Access Compliance Report

Public Rights-of-Way

(Curb Ramps)

Intersection ID: 31799	Main Street: ALMOND_RD	Cross Street: TRIPLE_J_CT	Location: SE
ADA ID: D36966A57D02	Ramp Type: Perp	Initial Pass/Fail: Fail	Overall Compliance: No
Codes/Mitigation Info/Possible Solution		Field Measurements/Component Compliance	
Severity Score: 1.25

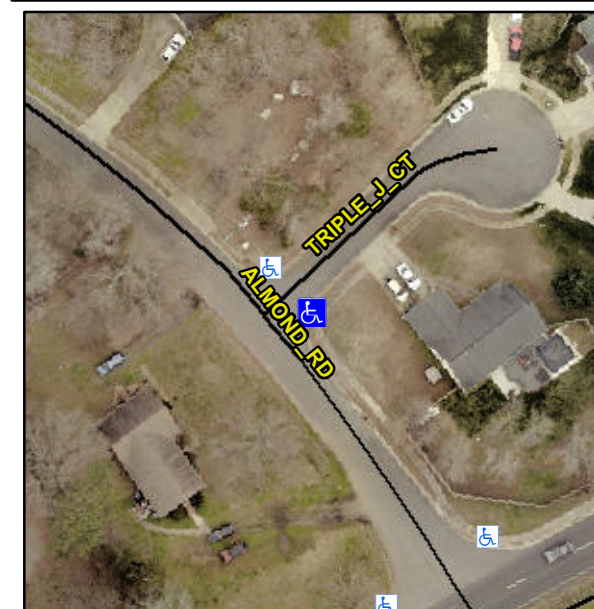
PROW/ADA:

Not Found, R304.5.3

Compliance	Description	Data	Compliance	Description	Data
N/A	Ramp Length (in)	47.0	Yes	Ramp Slope (%)	5.1
Yes	Ramp Width (in)	48.0	No	Ramp XSlope (%)	4.8
N/A	Flare Type LT	N/A	N/A	Flare Type RT	N/A
N/A	Flare Slope LT (%)	N/A	N/A	Flare Slope RT (%)	N/A
N/A	Flare Traversable LT?	N/A	N/A	Flare Traversable RT?	N/A
N/A	Landing Length (in)	N/A	N/A	DWS Provided?	N/A
N/A	Landing Width (in)	N/A	N/A	DWS Contrast?	N/A
N/A	Landing Slope (%)	N/A	N/A	DWS Length (in)	N/A
N/A	Landing X Slope (%)	N/A	N/A	DWS Full Width?	N/A
N/A	Landing Curb? (Y/N)	N/A	N/A	DWS Offset (in)	N/A
N/A	Shared Landing?	N/A			
N/A	Gutter Ponding?	N/A	N/A	Gutter Slope (%)	N/A
N/A	Gutter Lip Ht (in)	N/A	N/A	Gutter X Slope (%)	N/A
N/A	Painted X Walk1?	No	N/A	Painted X Walk2?	N/A
	X Walk 1 Direction	To NW		X Walk 2 Direction	N/A
N/A	X Walk 1 Width (in)	N/A	N/A	X Walk 2 Width (in)	N/A
	X Walk 1 Slope (%)	2.3		X Walk 2 Slope (%)	N/A
	X Walk 1 X Slope (%)	6.4		X Walk 2 X Slope (%)	N/A

Remove & Replace Entire Ramp.
